PROPOSED REPLACEMENT STAIRCASE AT 'THE MILL' 24, MANSFIELD COURT, BOLDON

PROPOSED PLANS SCALE 1:20

AMENDED PLAN

30/01/2019 ST0912/18/DO

PROPOSED FIRST FLOOR PLAN

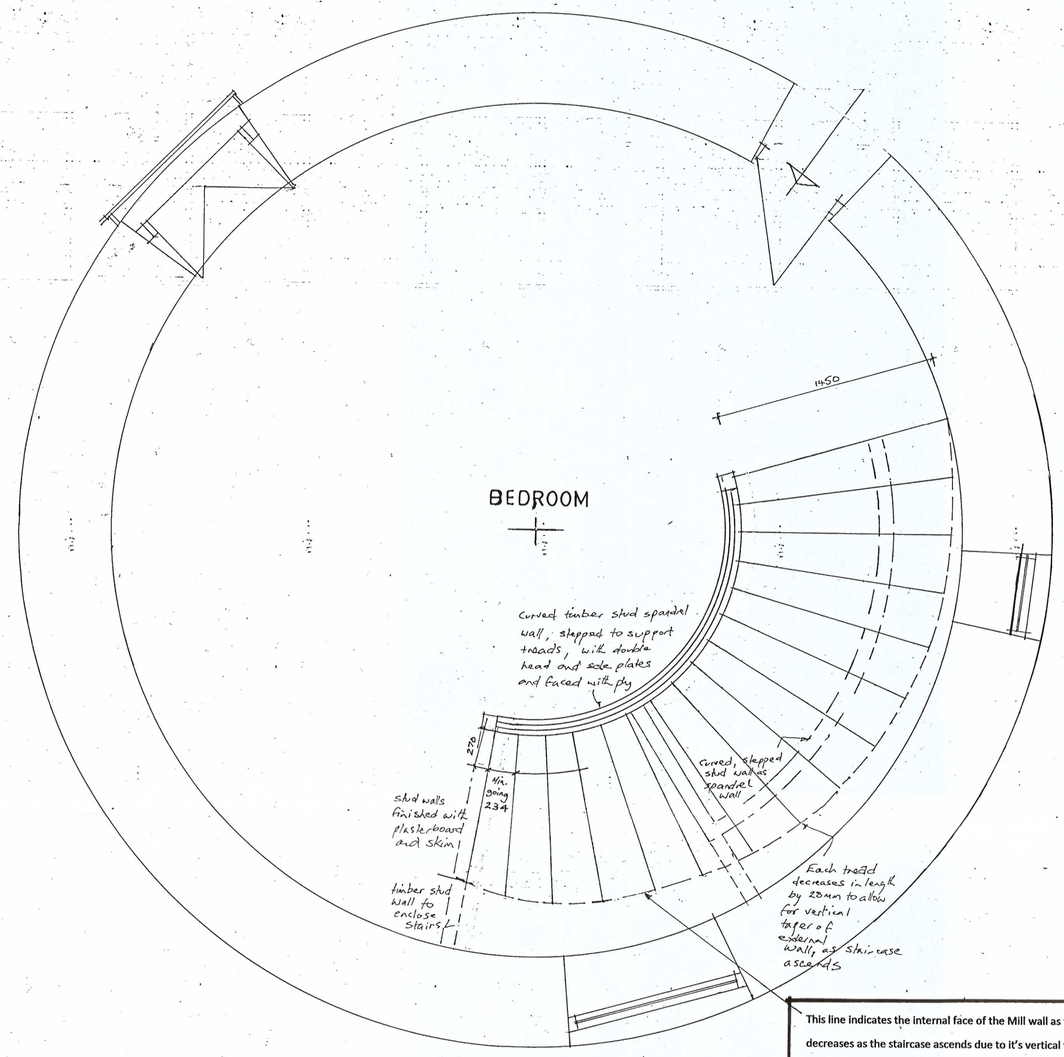
This line indicates the internal face of the Mill wall as the diameter of the Mill decreases as the staircase ascends due to it's vertical taper .
It does not indicate an ever increasing gap between the wall and the staircase.
The width of each tread decreases as the staircase ascends and each tread will butt up to the external wall but will not be built into it, so as not to interfere with the historic fabric.

PROPOSED SECOND FLOOR PLAN

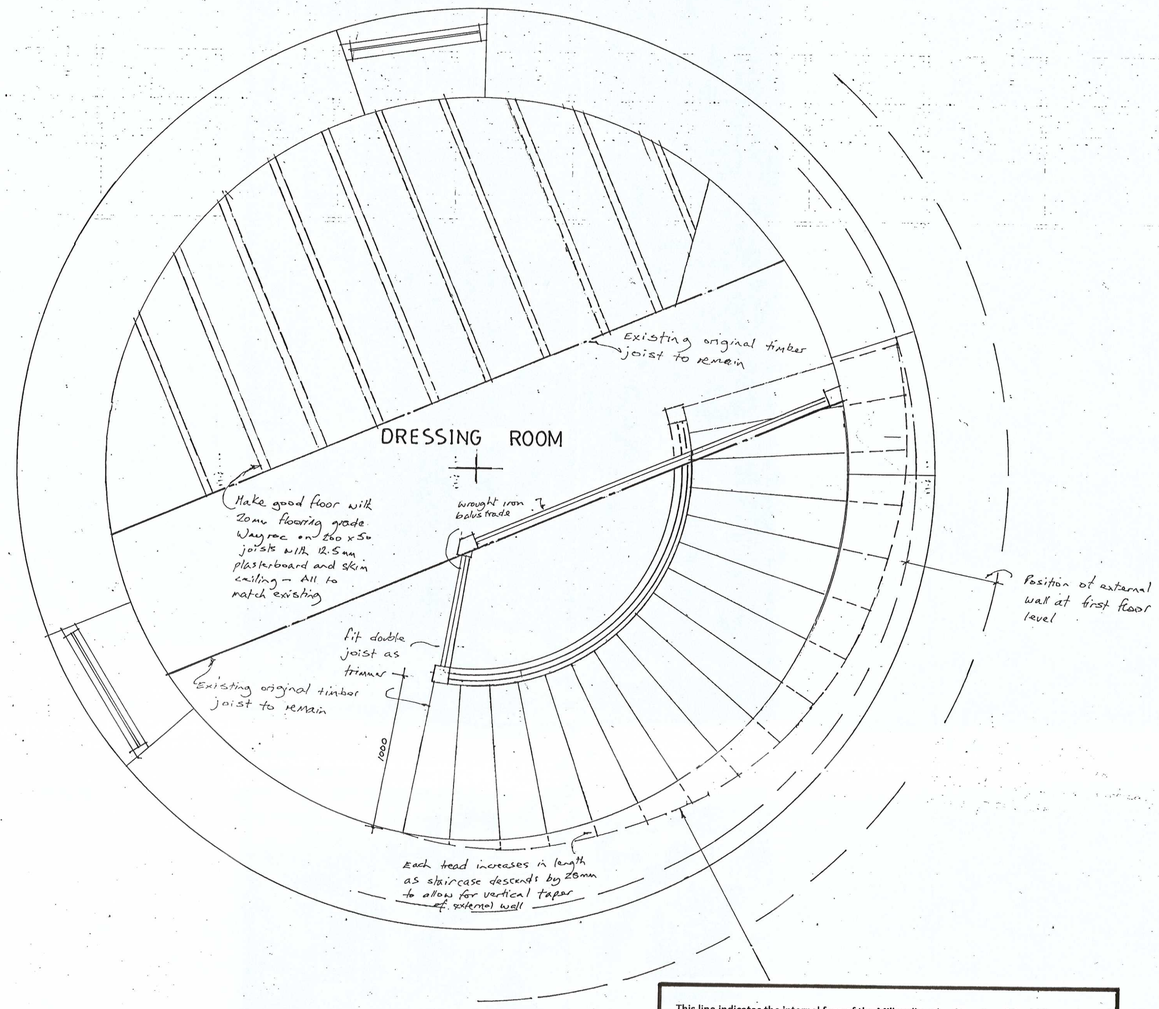
This line indicates the internal face of the Mill wall as the diameter of the Mill increases as the staircase descends due to it's vertical taper .
It does not indicate that the staircase has been drawn into the wall.
